ABBREVIATED PLAT AGENDA

STAFF REVIEW AND RECOMMENDATIONS
PUBLIC HEARING
MAY 8, 2024

ABBREVIATED PLAT: PATRICIA RSB LOT 1
LEGAL DESCRIPTION: SEC 04, T16N, R02W, SEWARD MERIDIAN AK
PETITIONERS: SOUTHCENTRAL FOUNDATION
SURVEYOR/ENGINEER: R & M CONSULTANTS, INC
ACRES: 15.366 ± PARCELS: 2
REVIEWED BY: MATTHEW GODDARD CASE #: 2024-056

REQUEST: The request is to create two lots from Lot 1, Patricia Subdivision, Plat No. 2005-120, to be known as **LOTS 1A & 1B**, containing 15.366 acres +/- . The property is located south of W. Carmel Road, west of Crocker Creek, and directly north and west of S. Knik Goose Bay Road; within the N ½ Section 4, Township 16 North, Range 02 West, Seward Meridian, Alaska. In the Knik-Fairview Community Council and in Assembly District #5.

PRELIMINARY PLAT OF PATRICIA SUBDIVISION LOTS 1A & 1B

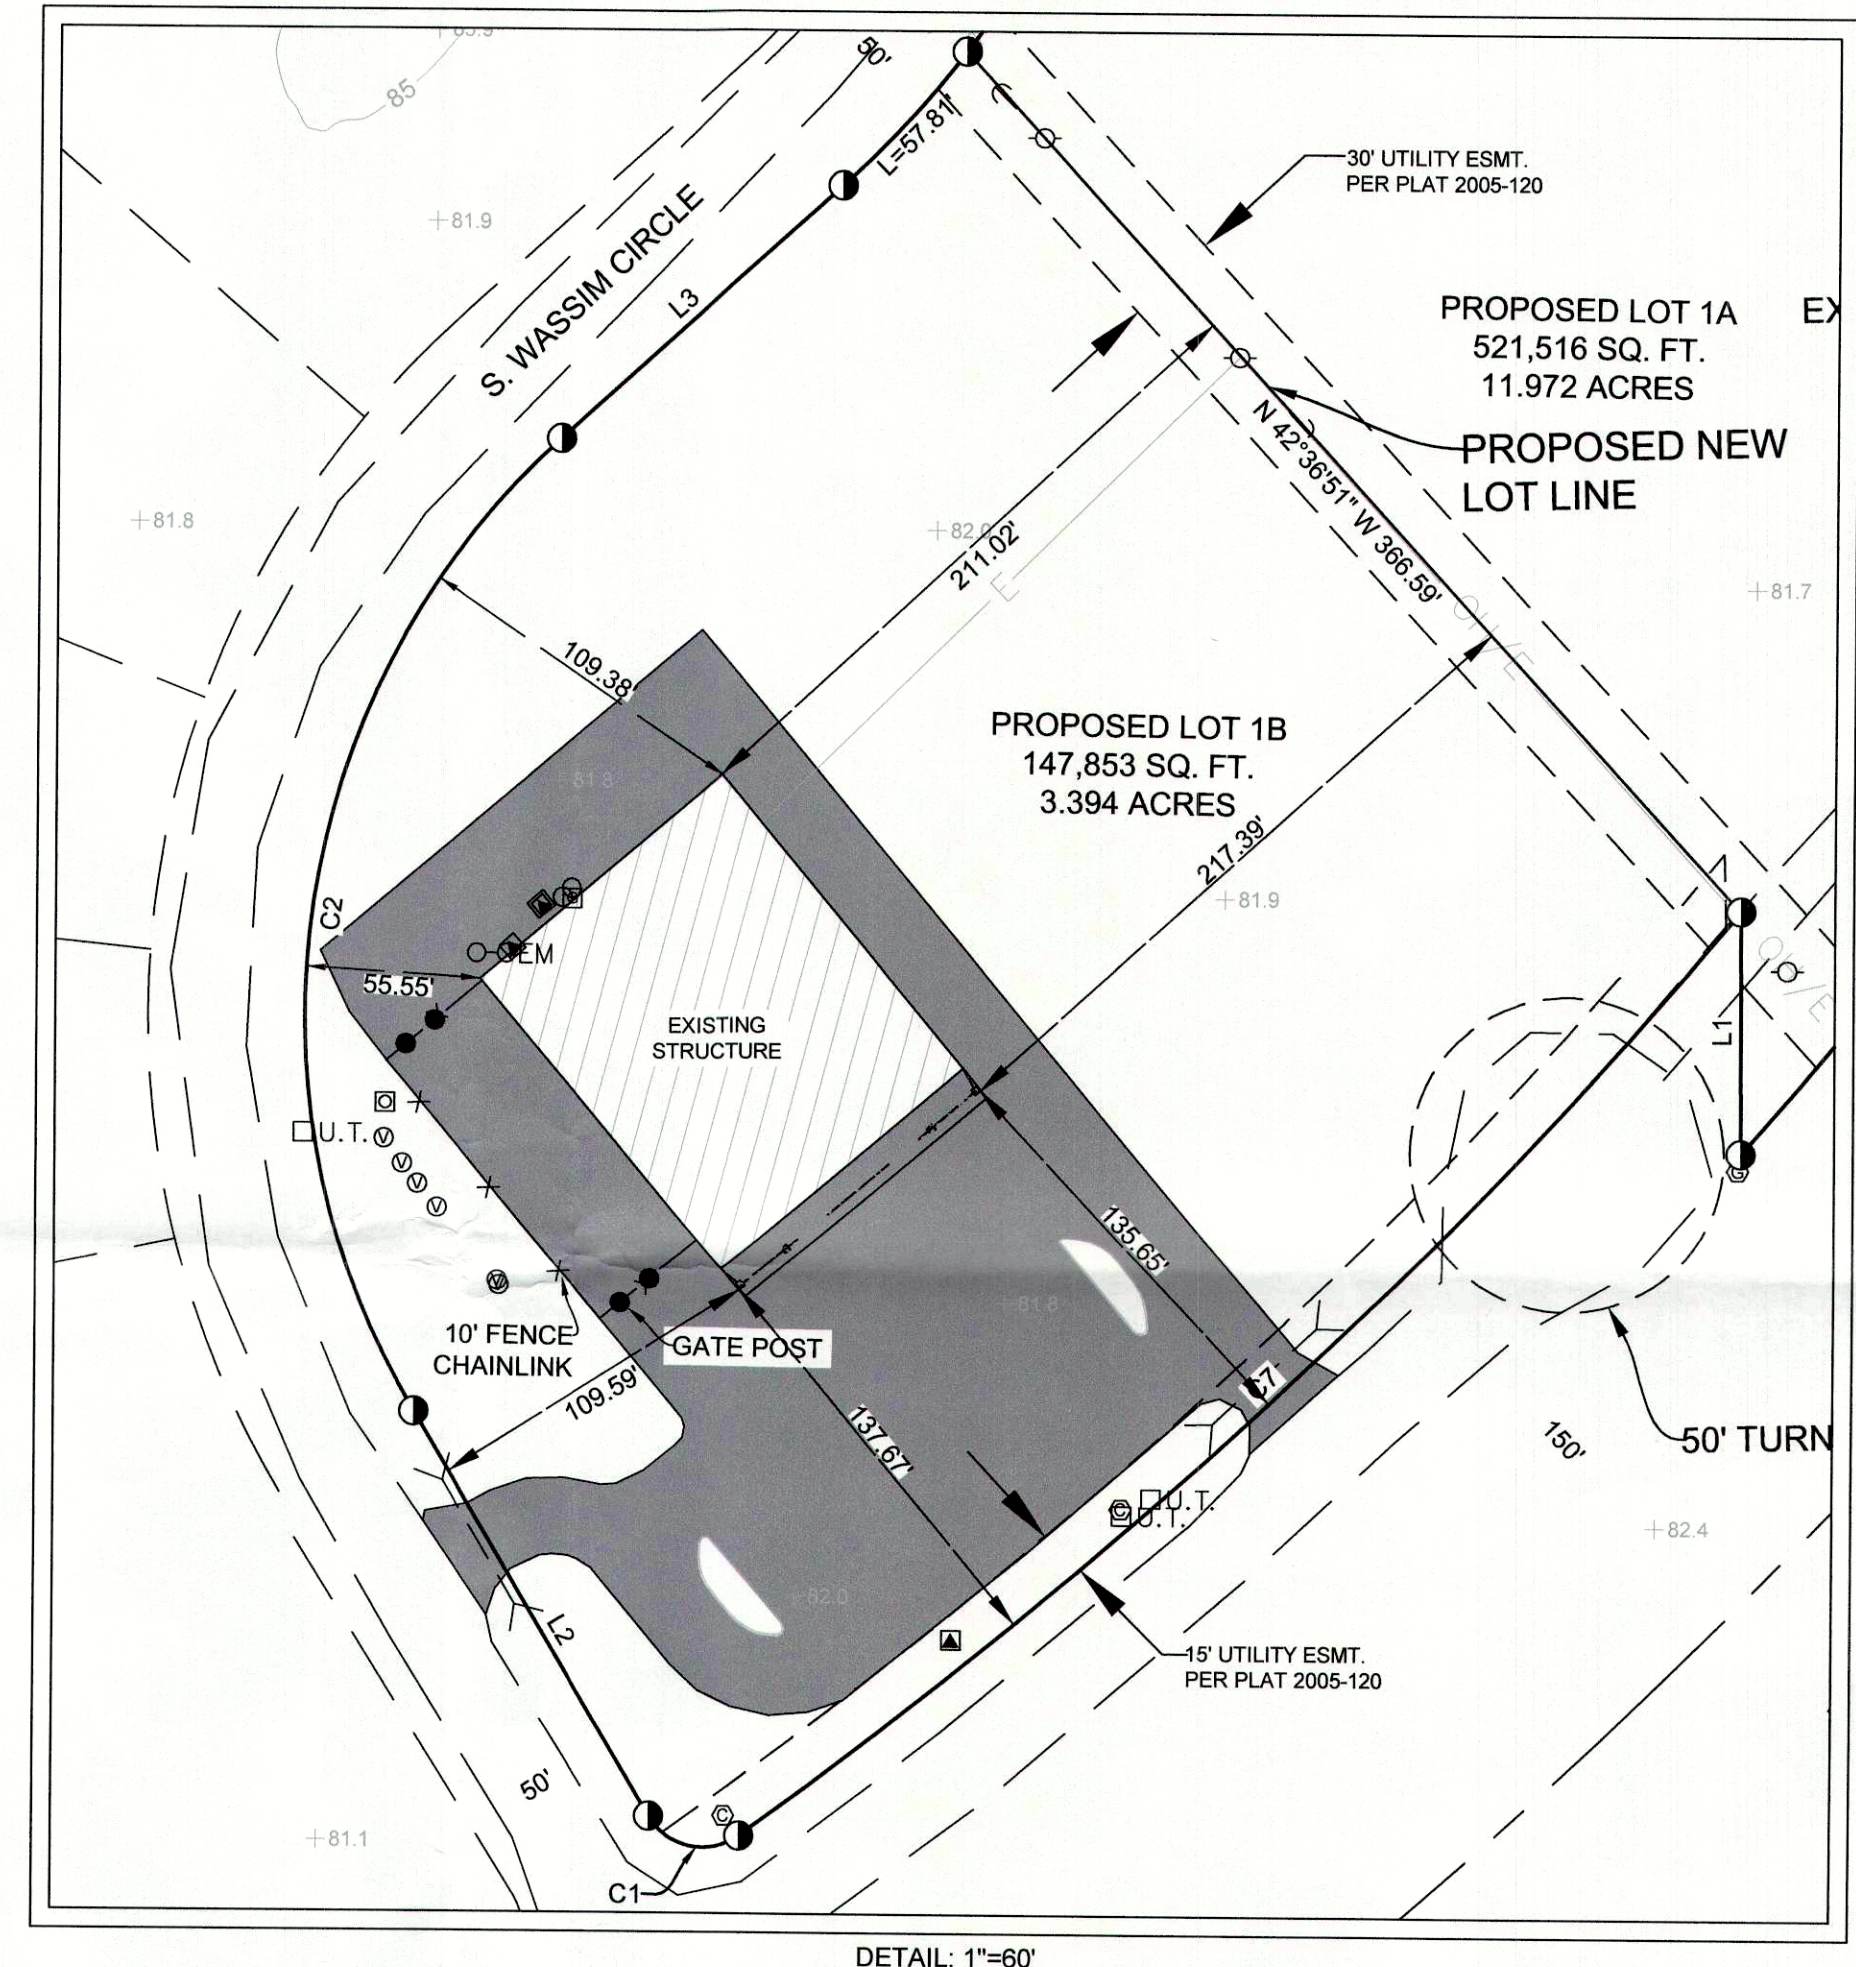
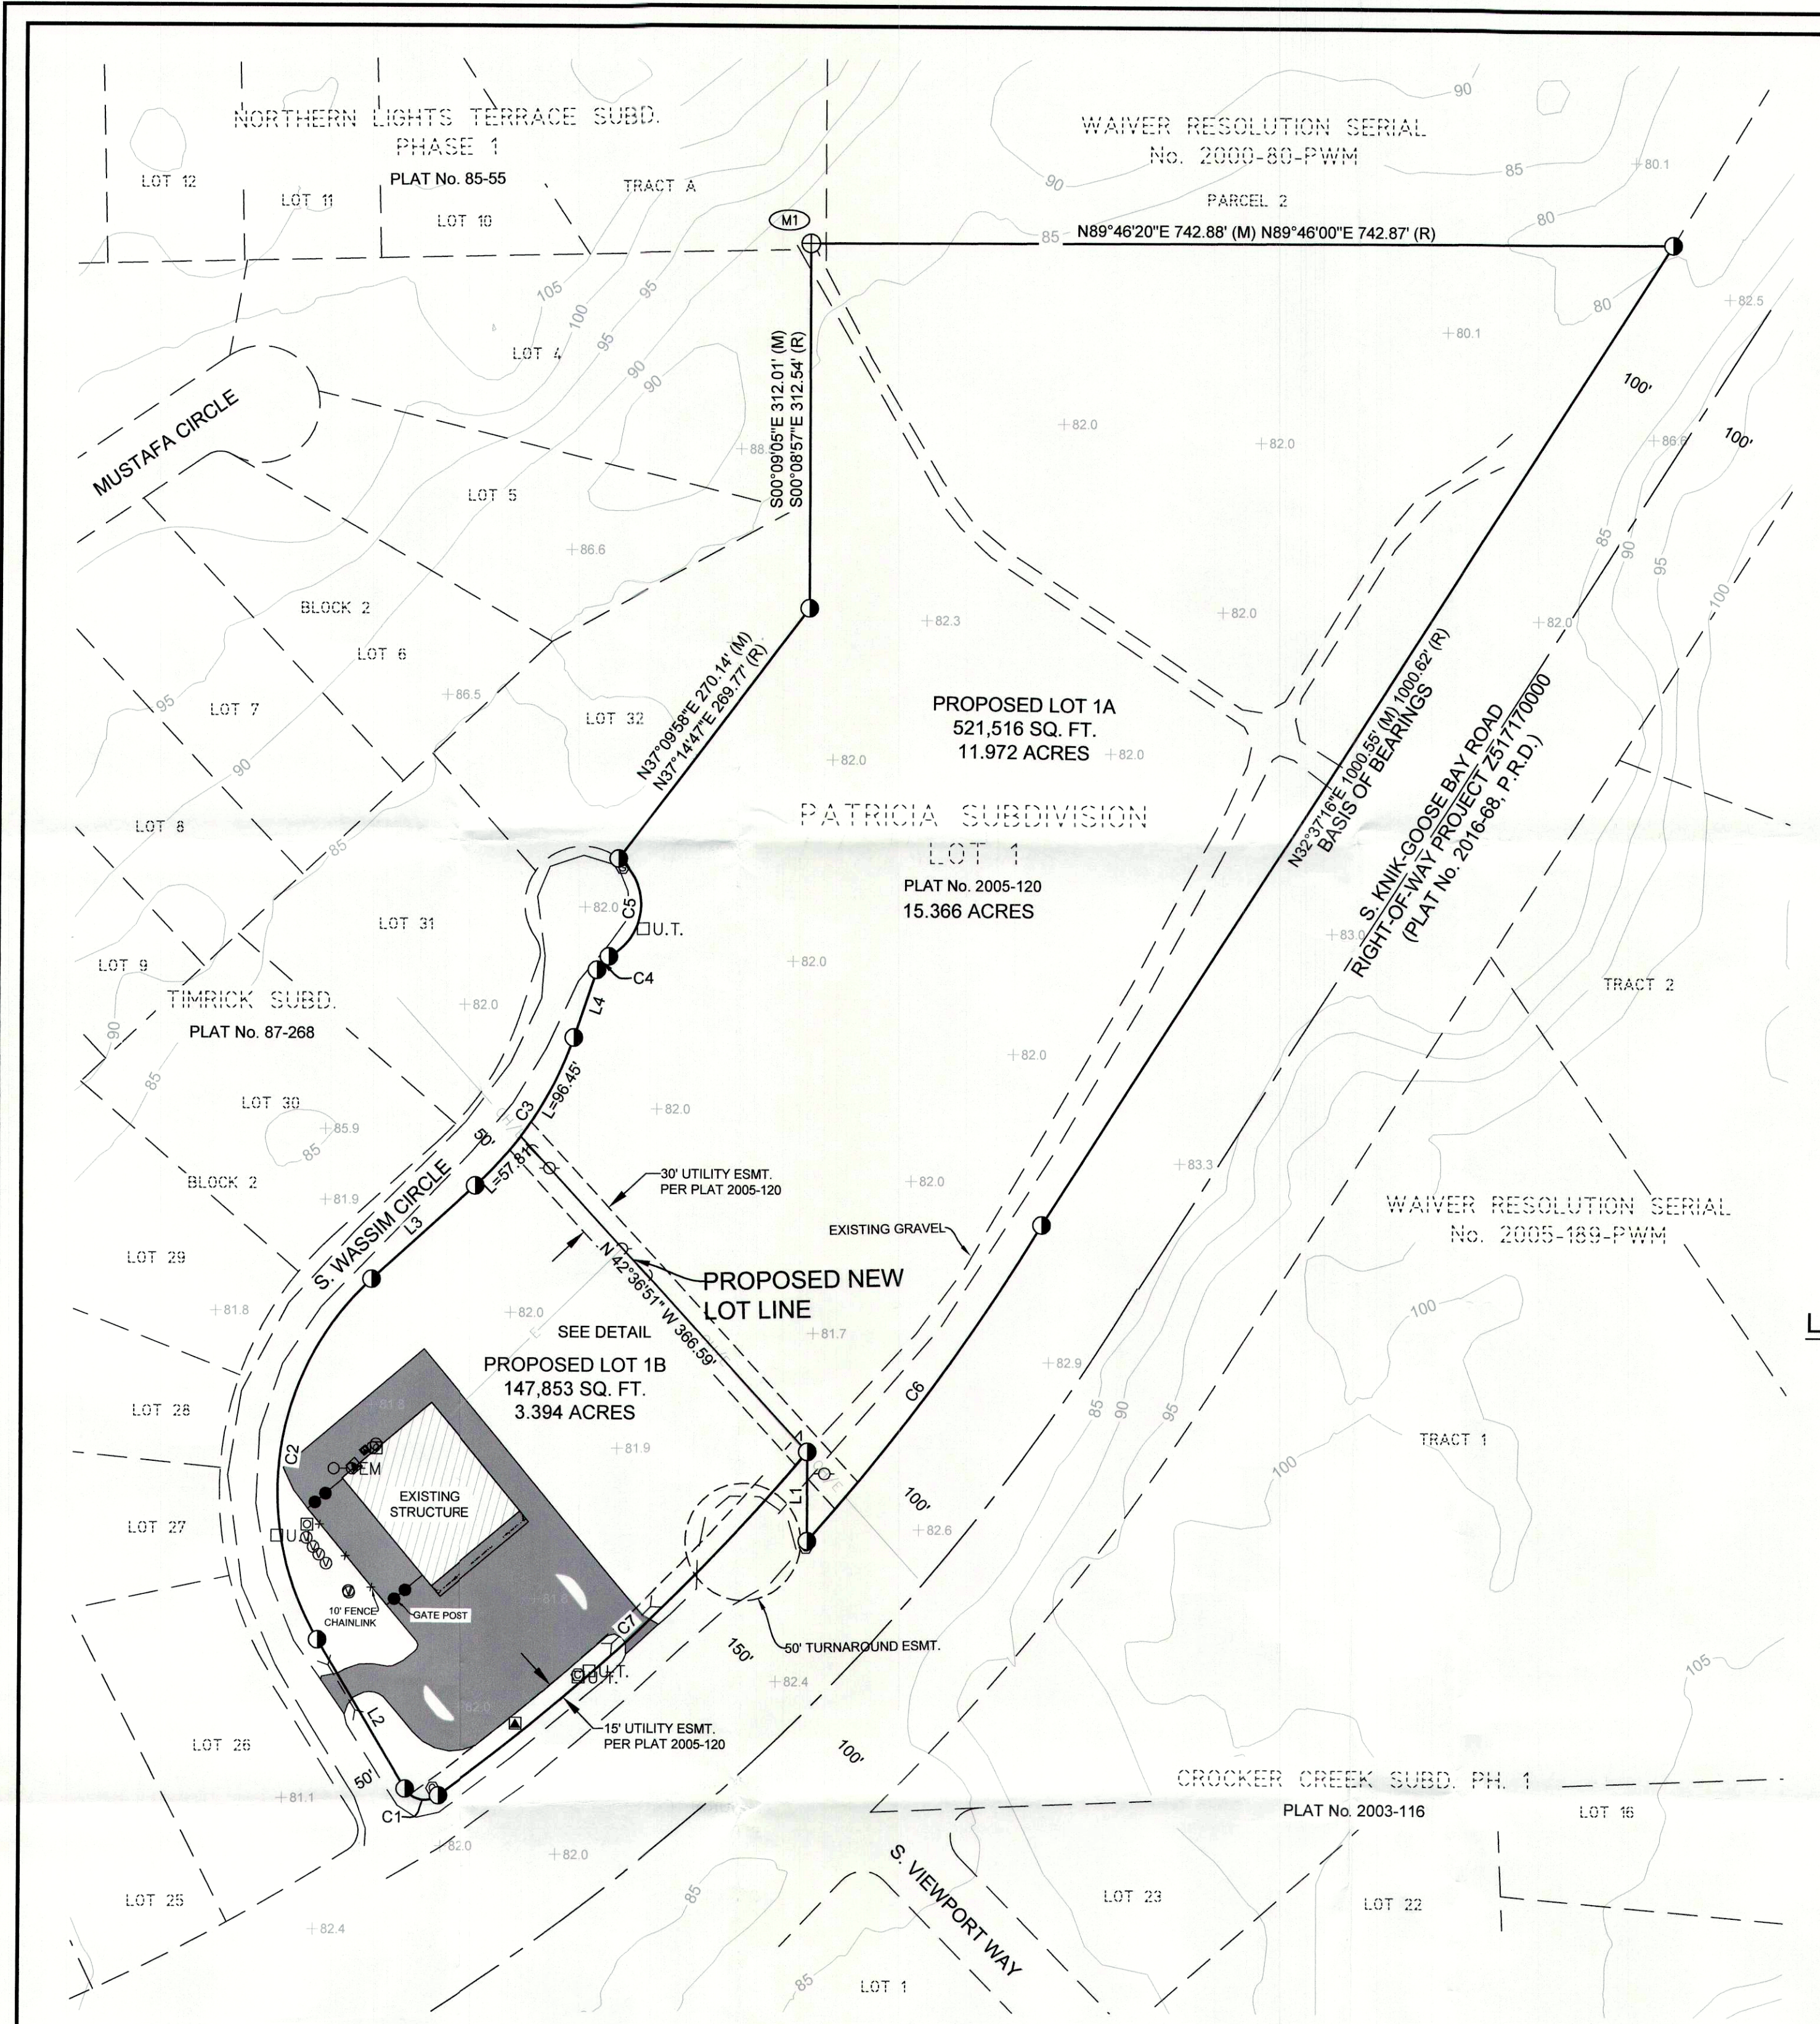
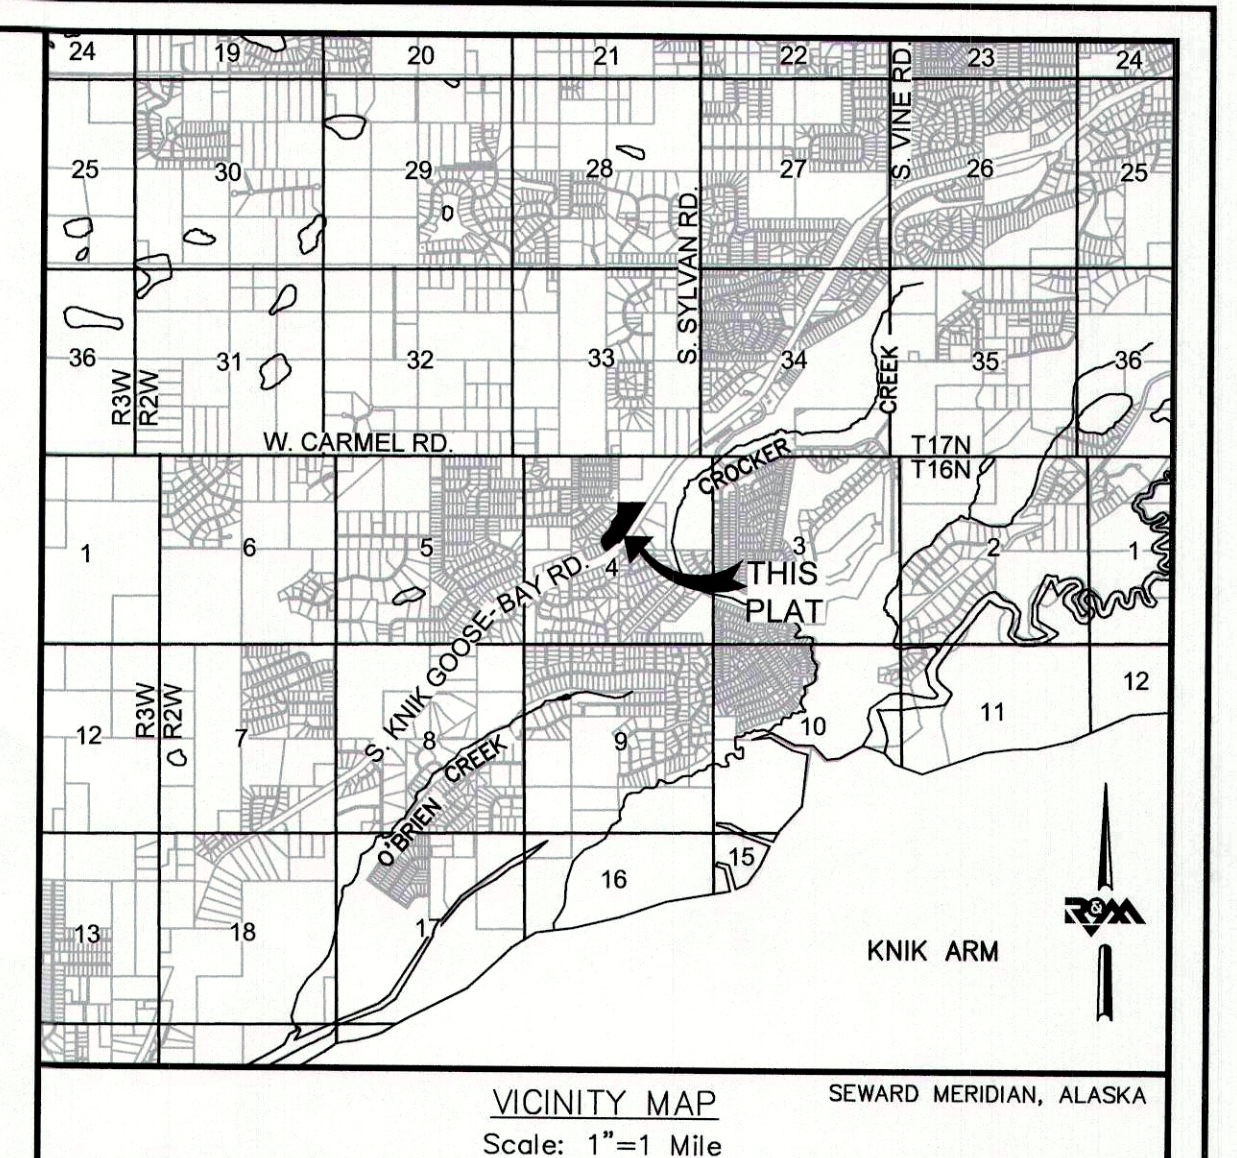
- No direct access shall be granted to S. Knik Goose Bay Road from either lot.
- Requests a plat note be added stating “No direct access to Knik Goose-Bay Road for Lot 1A or 1B.” (**Recommendation #4**)
- Requests a plat note be added stating “No direct access for utility connections through Knik Goose-Bay Road.”
- DOT&PF recommends development of internal circulation off Wassim Circle to avoid conflict with existing right of way users.
- DOT&PF recommends lot development consider the MSB Official Streets and Highway Plan’s future intersection at Knik Goose-Bay Road and Douglas Lane.
- DOT&PF recommends dedicating Wassim Circle and Douglas Lane on Lot 1A and Lot 1B.

MSB Department of Public Works (**Exhibit E**) notes that there should be no direct access from Lot 1A to Knik Goose-Bay Road.

Utilities: (**Exhibit G**) Enstar notes that there is a high-pressure natural gas transmission pipeline within S. Knik-Goose Bay Road ROW. ENSTAR should be notified prior to any excavation or construction within 25 FT of the S. Knik Goose-Bay Road ROW. GCI has no objections or comments. MEA did not respond. MTA did not respond.

- Please add as plat note: "No direct access to Knik Goose-Bay Road for Lot 1A or 1B."
 - Please add as plat note: "No direct access for utility connections through Knik Goose-Bay Road."

- DOT&PF recommends lot development consider the Mat-Su Borough's [Official Streets and Highway Plan](#)'s (OSHP) future intersection at Knik Goose-Bay Road and Douglas Lane. View the OSHP by selecting the "Official Streets and Highways Plan" and "OSHP Primary Intersection" layers in the [MSB Planning and Land Use Viewer](#)'s Layer List.
- Recommend dedicating Wassim Circle and Douglas Lane on Lot 1A and Lot 1B.

1. Taxes and special assessments must be paid in full for the year of recording, pursuant to MSB 43.15.053(F) and AS 40.15.020. Pay taxes and special assessments (LIDs), by CERTIFIED FUNDS OR CASH.
2. Provide updated Certificate to Plat executed within seven (7) days of recording of plat and submit Beneficiary Affidavit for any holders of a beneficial interest.
3. Pay postage and advertising fees.
4. Add a plat note stating "No direct access shall be granted to S. Knik Goose-Bay Road unless otherwise authorized by the permitting authority."
5. Show all easements of record on final plat.
6. Submit recording fees, payable to Department of Natural Resources (DNR).
7. Submit final plat in full compliance with Title 43.
